# FINDINGS OF FACT AND CONCLUSIONS

*RUSH LINE BUS RAPID TRANSIT PROJECT ENVIRONMENTAL ASSESSMENT*

OCTOBER 2021

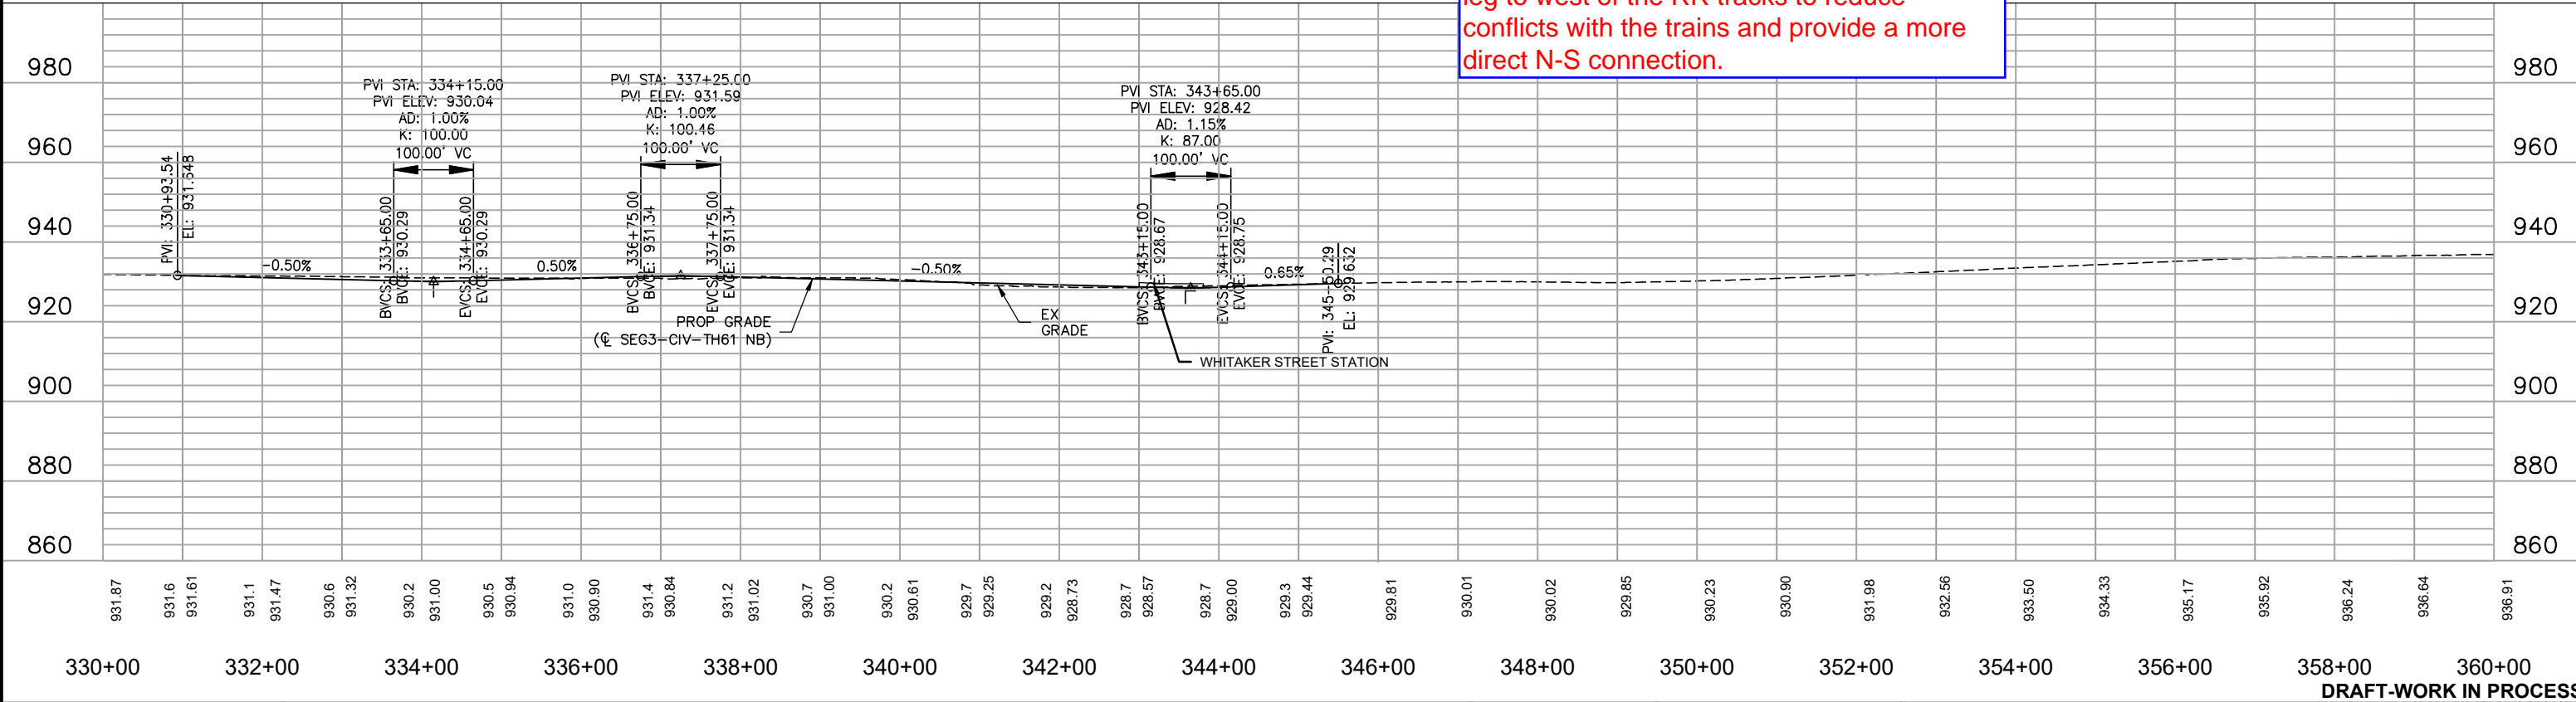
Sheet 27: <ul style="list-style-type: none"> <li>A signal replacement project (6222-120) for FY 26 will replace all signals at this intersection as well as make ADA and pedestrian and bike facility improvements. All 4 legs will include crossings and the connection between Bruce Vento Trail and Mark Sather Trail is being planned for. Discussions are currently underway to potentially shift the N-S crossing of the west leg to west of the RR tracks to reduce conflicts with the trains and provide a more direct N-S connection.</li> </ul>	Project staff will coordinate with the Minnesota Department of Transportation on SP 6222-120 as engineering advances.
<b>Water Resources</b>	
Appendix F – Other Supporting Technical Information, Utilities Memorandum, Existing Conditions should also mention the Minnesota Department of Transportation as owning and maintaining Storm Sewer. The current writeup appears to miss this, despite noting that we did provide storm sewer information for their use for the EAW.	Comment noted. It is acknowledged that the Minnesota Department of Transportation also owns and maintains storm sewer within the study area. Project staff will coordinate with the Minnesota Department of Transportation regarding potential impacts to existing facilities as engineering advances.

A signal replacement project (6222-120) for FY 26 will replace all signals at this intersection as well as make ADA and pedestrian and bike facility improvements. All 4 legs will include crossings and the connection between Bruce Vento Trail and Mark Sather Trail is being planned for. Discussions are currently underway to potentially shift the N-S crossing of the west leg to west of the RR tracks to reduce conflicts with the trains and provide a more direct N-S connection.
